This is to certify that RANDALL BRIAN & ALEXANDER BEAL ITS/Alan Mon  
 has permission to renovate kitchen, change size of existing windows, close chimney, move 1 door  
 AT 381 DANFORTH ST 061 E009001

Permit No: 05-1685	Issue Date: DEC 5 2005	061 E009001
Owner Address: 381 DANFORTH ST		Phone:
Contractor Address: 277 Long Hill Road Sebago		Phone: 2077560436
Permit Type:		Zone: R4

**Proposed Project Description:**  
renovate kitchen, change size of existing window, enclose chimney, move 1 door

CHIMNEY DETAIL

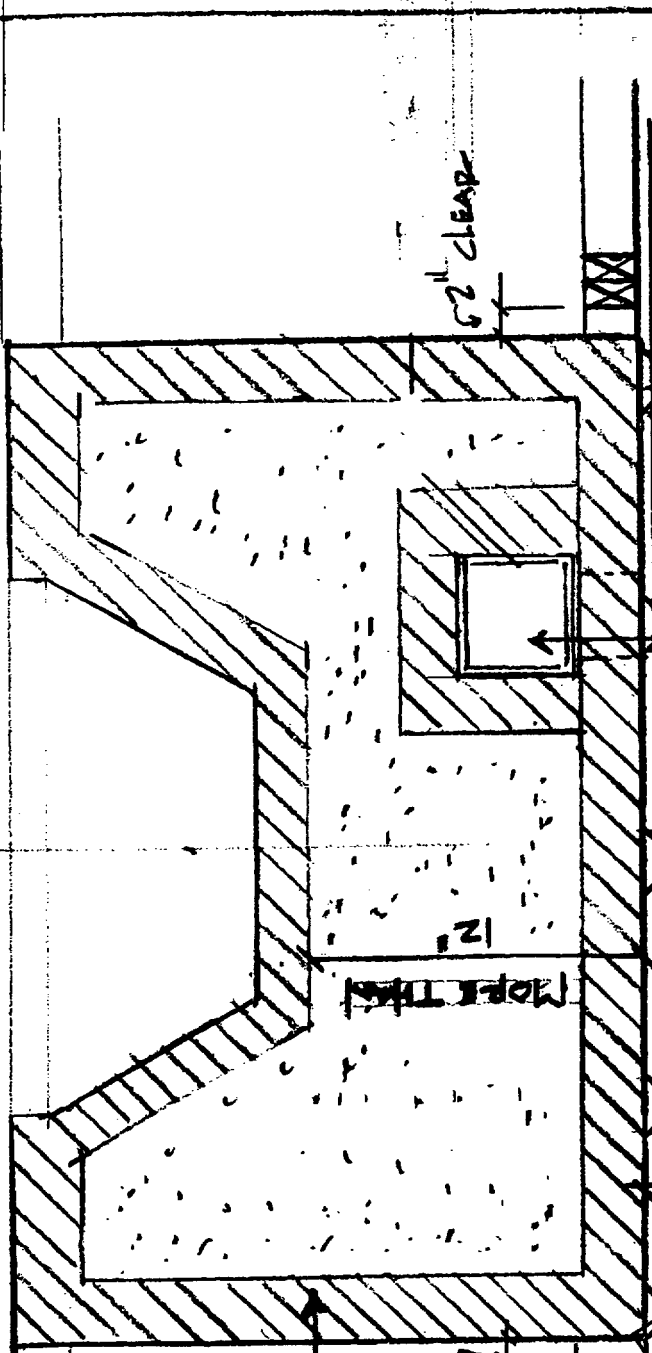
EXISTING  
SOLID MASONRY  
CHIMNEY

DISCONTINUED EXISTING  
FLUE BRICK MASTER OPENING  
METAL CHANNEL FASTENED  
TO FACE OF CHIMNEY 16" ON  
5/8" FIRE RATED GWB
